**Addendum No. 1**

**For Project No. ENG2403779005  
GARRISON INTERIOR REMODEL PROJECTS  
Fort Harrison State Park  
Marion County**

**ISSUE DATE: December 8, 2023**

ADA VANITY DETAIL

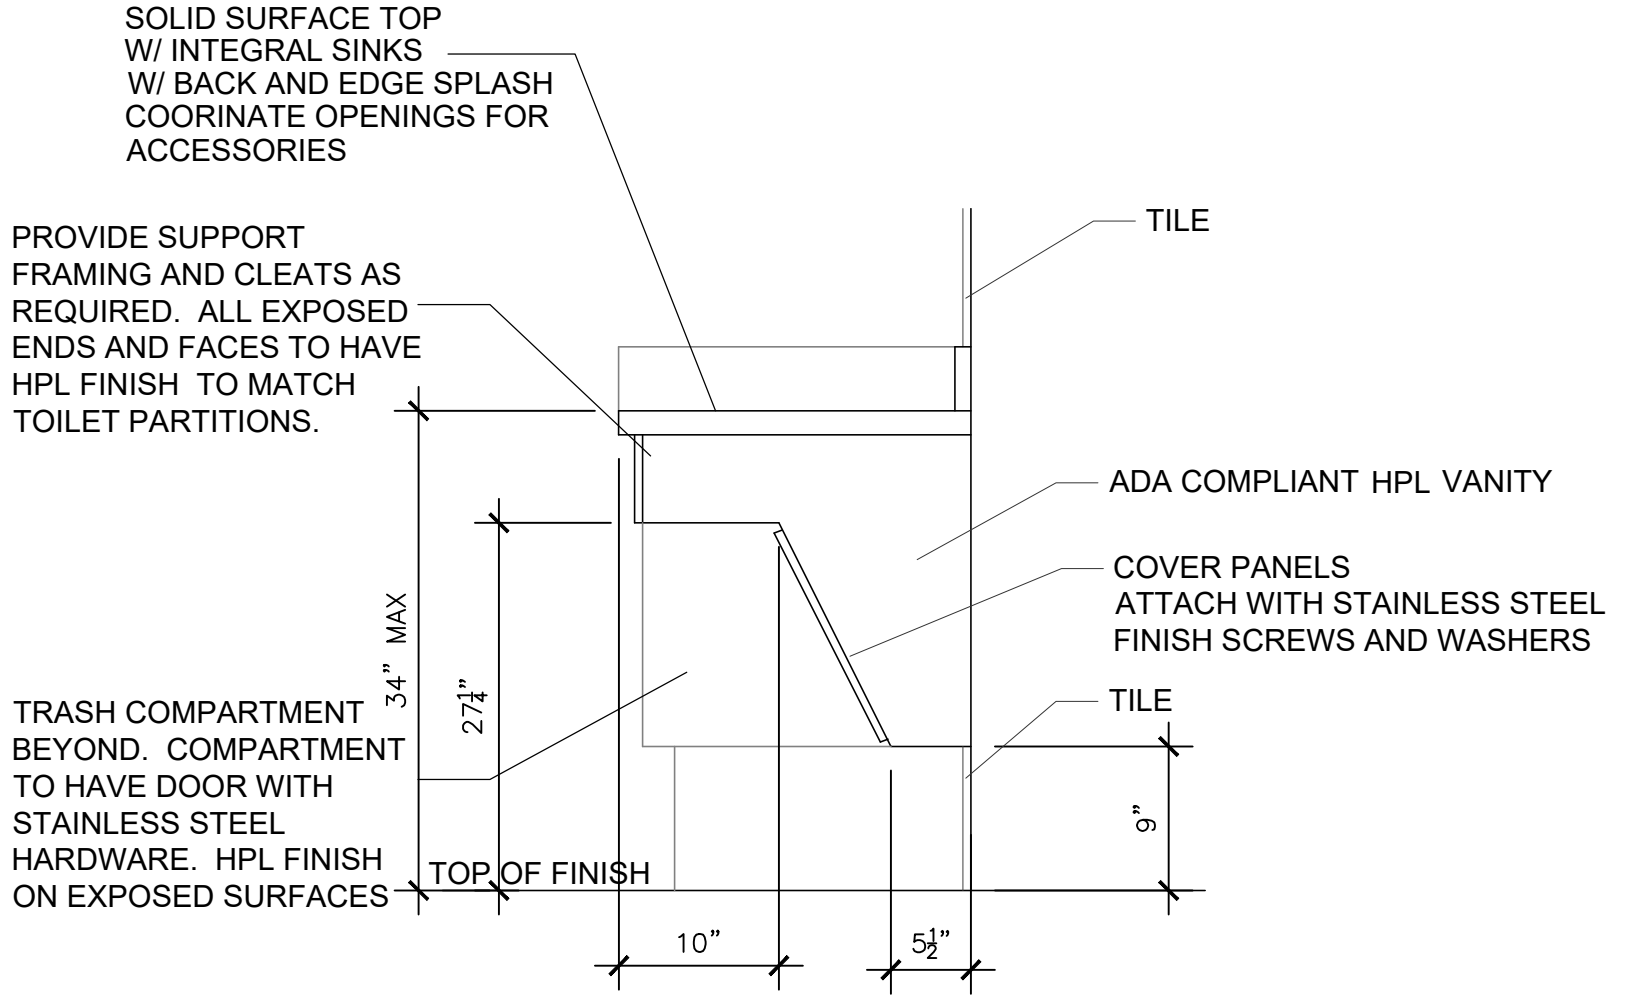
11. Q: How much room is above ceilings in restroom?  
A: Contractor shall field verify field conditions. The area above the restroom can be viewed from the existing chase. Coordinate viewing with property staff.
12. Sheet A-1 – Add  
Add note to Floor Plan Keynotes – “All toilet room accessories to have concealed fasteners.”
13. Sheet A-4 – Clarification  
Flooring Replacement Scope Note #4. For purposes of Bidding: Assume 30% of subfloor will be replaced.
14. Sheet A-3 – Revision  
Detail 10/A-3 ADA Vanity Detail. See attached.
